December 27, 2023
Subject: Large Culvert Replacement
State WIN: 023551.00
Location: **Dayton**
Amendment No. 3

ROUTE 5 CULVERT IMPROVEMENTS
STATE PROJECT NO. 23551.00
PROJECT LENGTH : 0.03± MILES

DAYTON	ROUTE 5
TITLE SHEET

PLAN VIEW

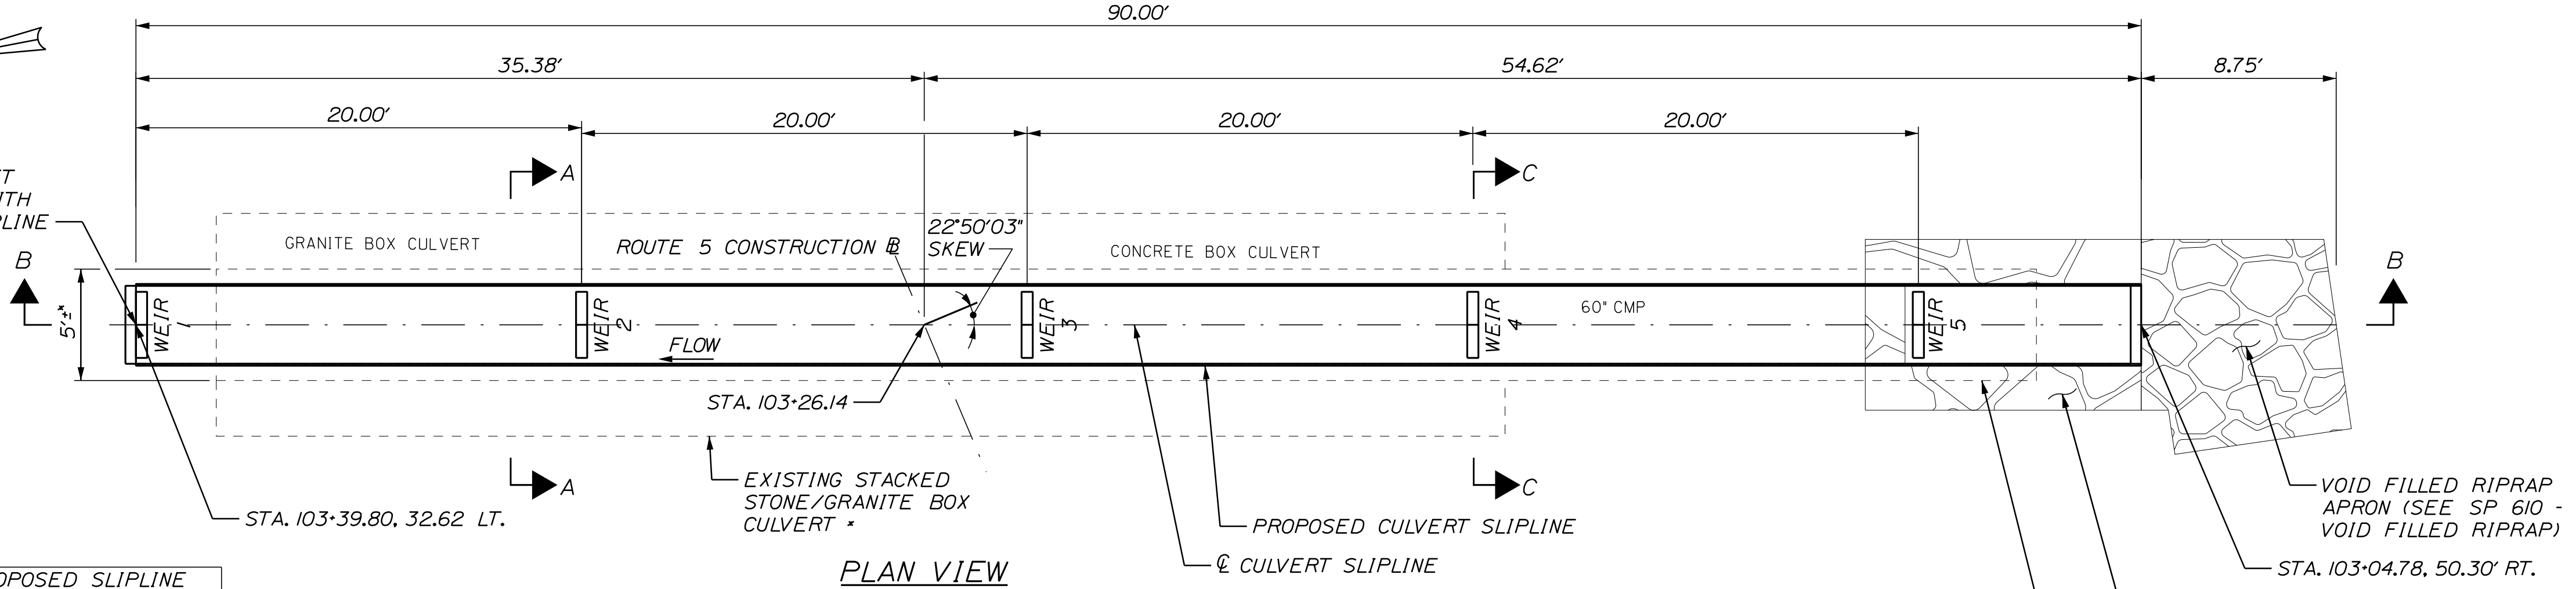
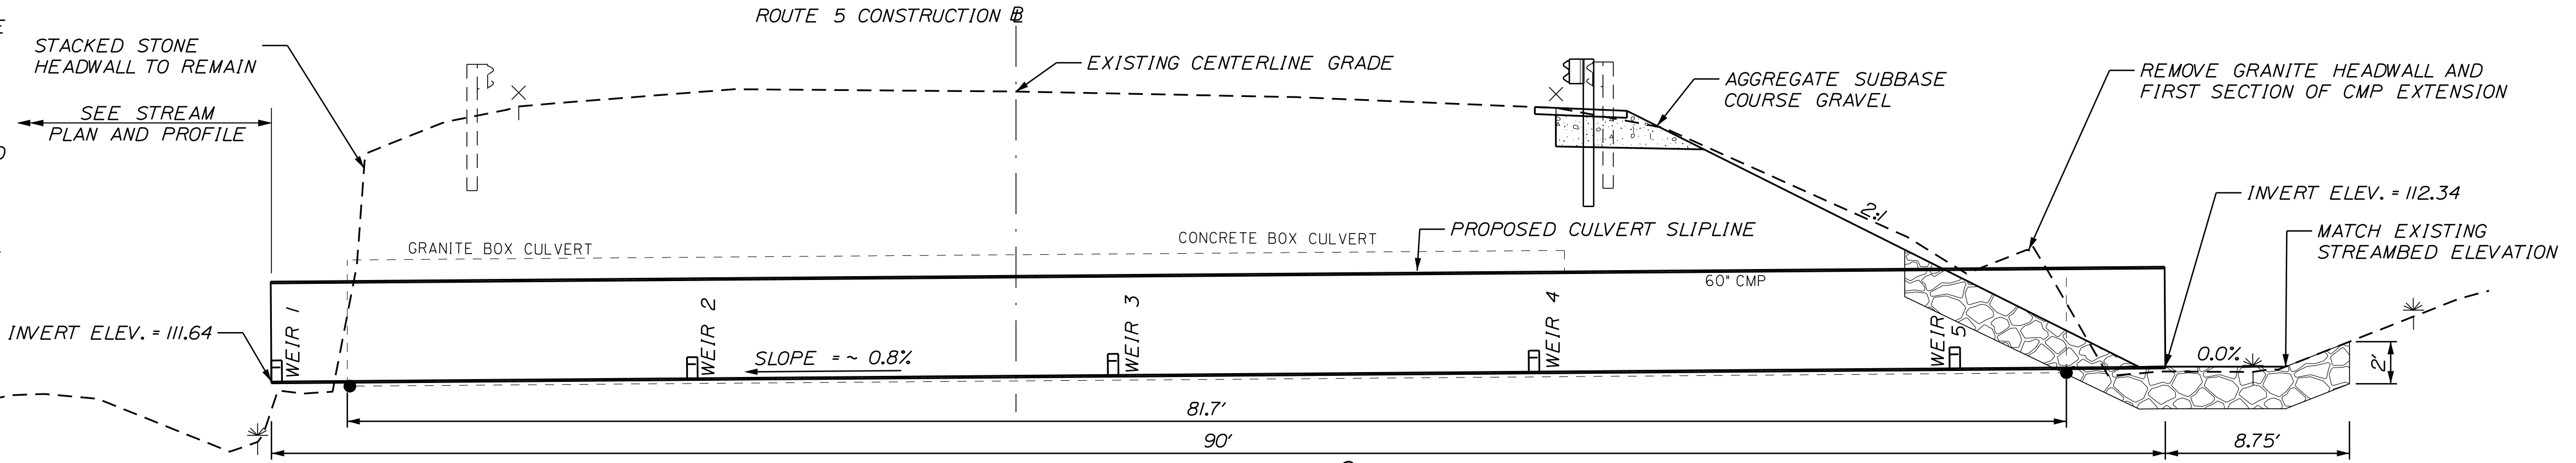
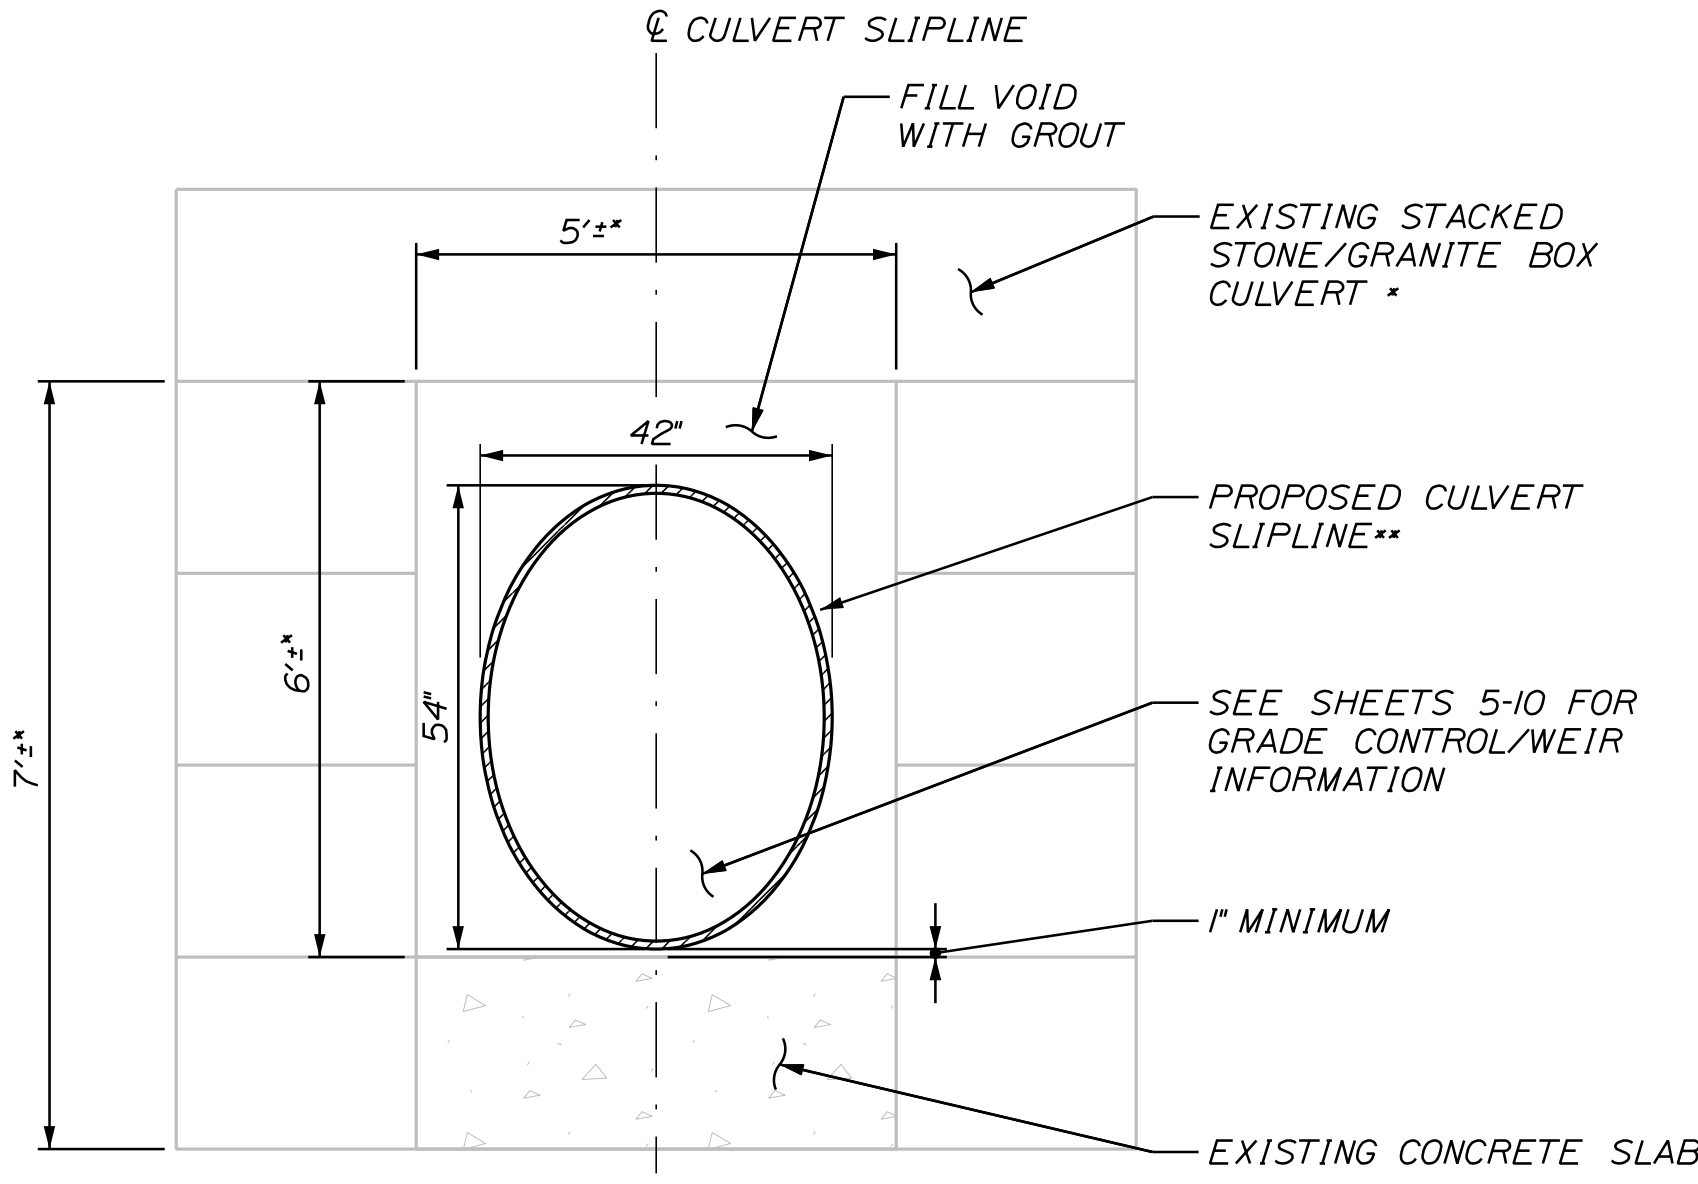
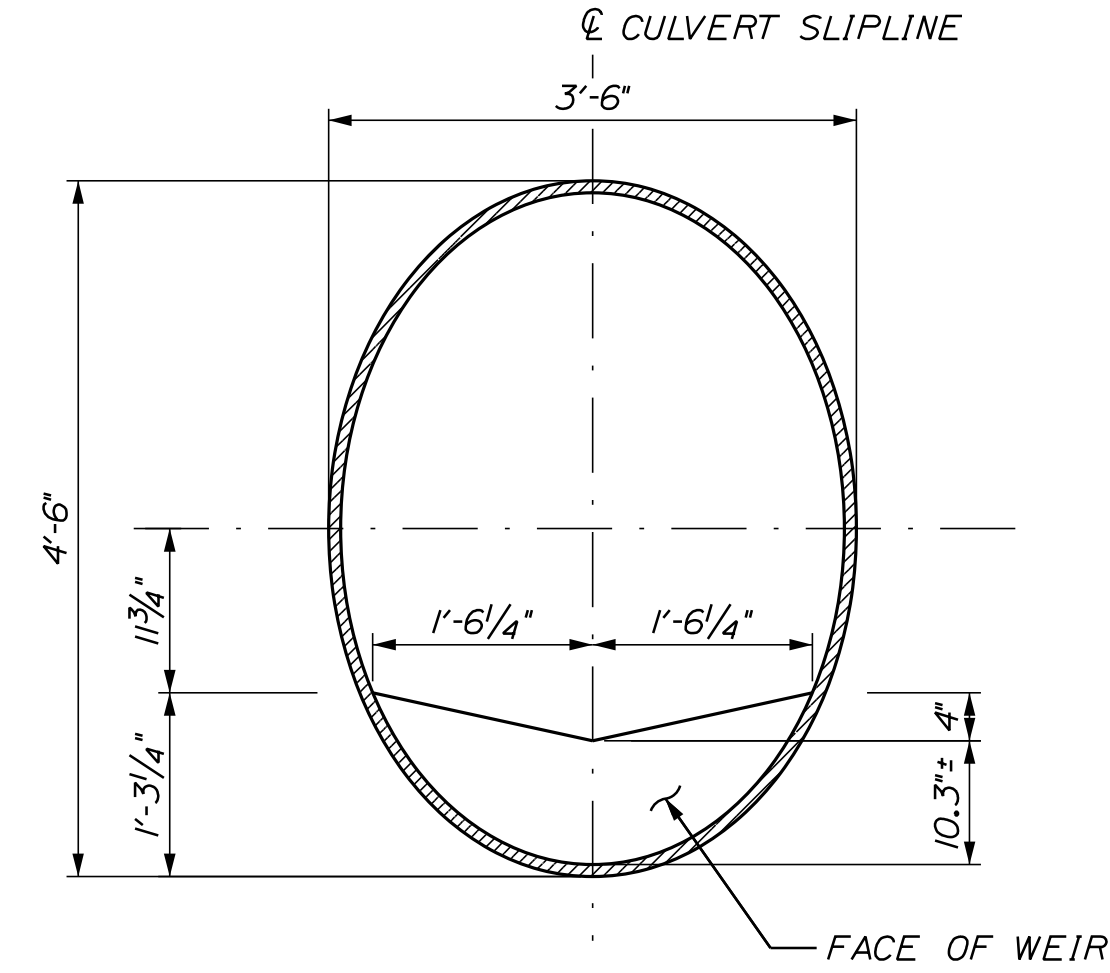
Question: The upstream portion measures between 54" and 60" through the host CMP, while the granite/stone box measures closer to 44" horizontal axis in some spots. Are we to assume that some mild cutting/removal of the host stones is going to be required?

Question: We might be able to sneak 54" HDPE (OD) through the CMP and then line with box culvert with box shaped GRP similar to what the State did in St. John's Plantation this past summer. Alternatively, we could use Tunnel Liner Plate and try to chip away at the rock in the box culvert portion.

Response: Please refer to the revised plan set for the maximum allowable outside dimensions.

Response: Please refer to the revised plan set for the maximum allowable outside dimensions.

- WEIR THICKNESS SHOWN IS APPROXIMATE. ACTUAL WEIR THICKNESS WILL BE DETERMINED BY THE MANUFACTURER.
- THE PROPOSED CULVERT SLIPLINE SHALL HAVE MAXIMUM OUTSIDE DIMENSIONS OF 42" WIDE AND 54" TALL. PROPOSED CULVERT SLIPLINE DIMENSIONS SHOWN ON THE PLANS AND DETAILS ARE APPROXIMATE. DIMENSIONS MAY NEED TO BE ADJUSTED DUE TO FINAL CULVERT SLIPLINE SIZE/WALL THICKNESS/SHAPE CHOSEN BY THE CONTRACTOR.
